INA Service Info

Deflection pulley 532 0471 10

Visual differences

Part no.: 532 0471 10

Fig. 1: 532 0471 10 - old design

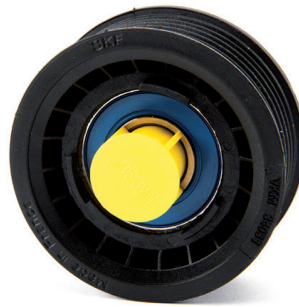
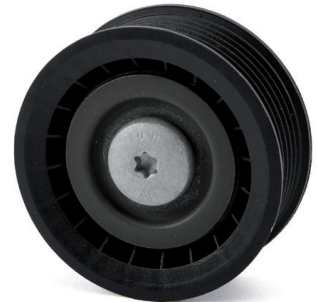
As part of the on-going development of our products, deflection pulley 532 0471 10 has been modified.

In the previous design, the bolt is held in place with a yellow plastic retainer (Fig. 1). That retainer must be removed before installing the deflection pulley, but once it has been removed, the bolt could fall out.

The new design features a captive bolt that cannot fall out or be lost.(Fig.2). As a result, the deflection pulley will always be supplied with the bolt.

Both design configurations meet the technical specifications and can be used without restriction.

During the transition period, stocks may become mixed.
